ADMINISTRATIVE APPROVAL Area Injection Order 13A.001

RE: Area Injection Order 13A
Request for Administrative Approval
Rule 2: Authorized Injection Strata for Disposal
Swanson River Field

Figure 1. SRU 32-33 Well Log

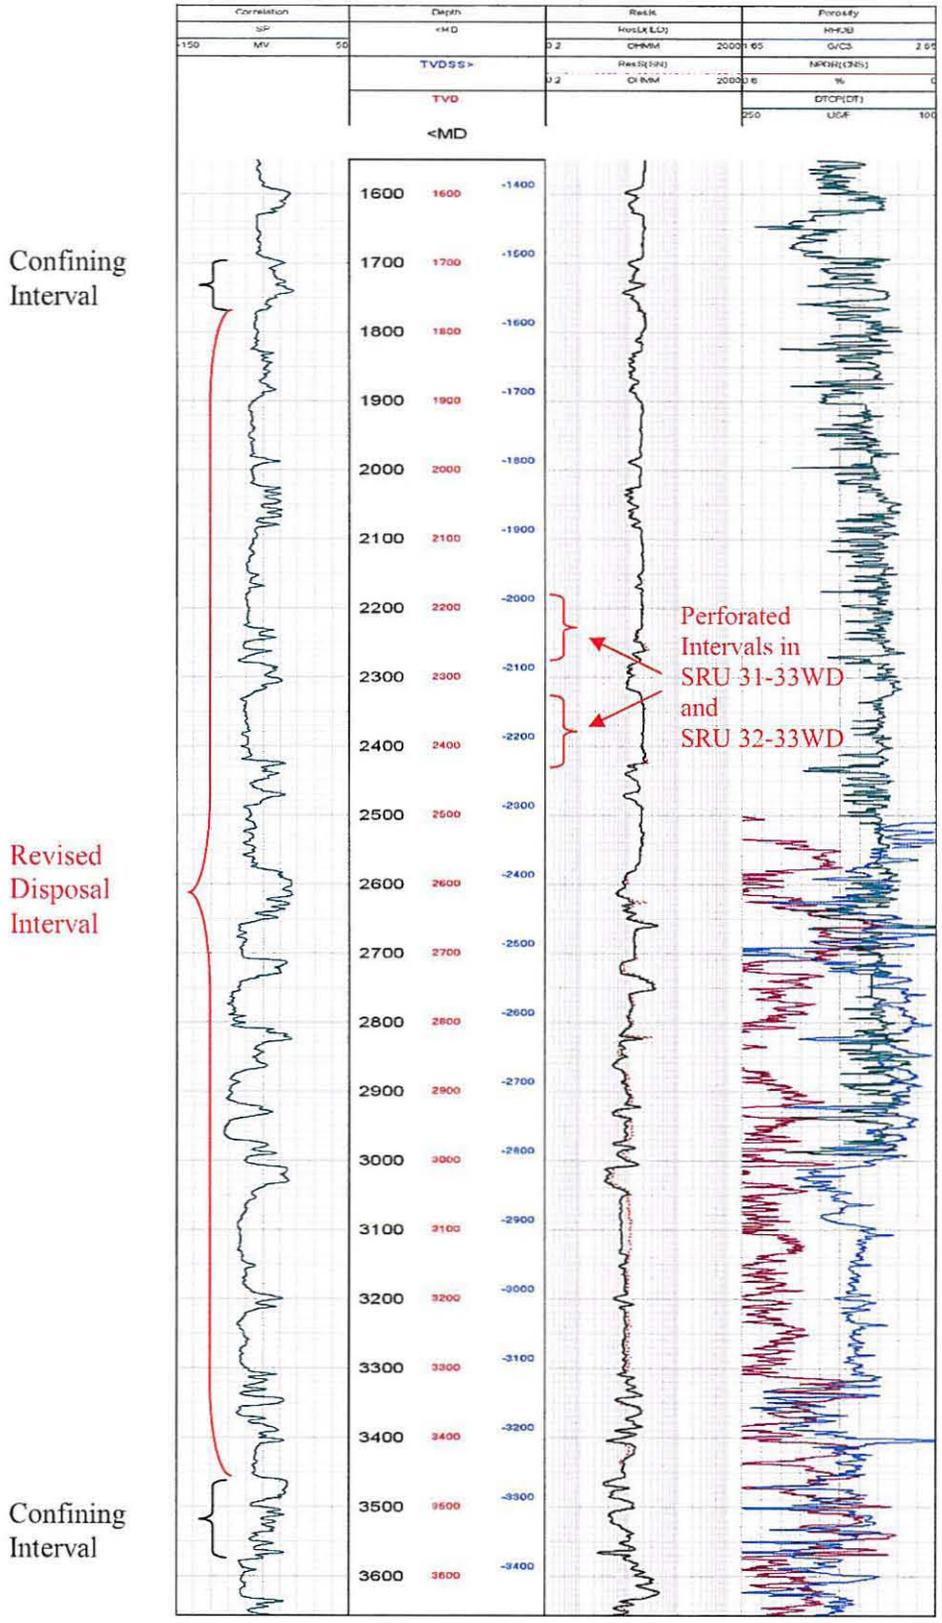
3. Upper confinement for injected waste is provided by a 30- to 50-foot thick interval of interbedded layers of claystone and siltstone with minor sandstone that lies between 1,695 feet and 1,745 feet MD in SRU 32-33 (see Figure 1, below). This confining interval is present on well logs and appears to be continuous for a radius of ½ mile around the active SRU 31-33WD and SRU 32-33WD disposal wells.

4. Lower confinement for injected waste is provided by a 115-foot thick interval that lies between about 3,460 feet and 3,575 feet MD in SRU 32-33. This interval contains an aggregate thickness of about 55 feet of interbedded claystone, siltstone and coal that will provide an effective bottom seal for the injected fluids. This confining interval appears to be continuous for a radius of ½ mile around SRU 31-33WD and SRU 32-33WD.

Within the affected area non-hazardous oil field fluids may be injected for the purpose of disposal into strata defined as those strata that are common to, and correlate with, strata found in well SRU 32-33 between the measured depths of 1,745 feet and 3,460 feet.
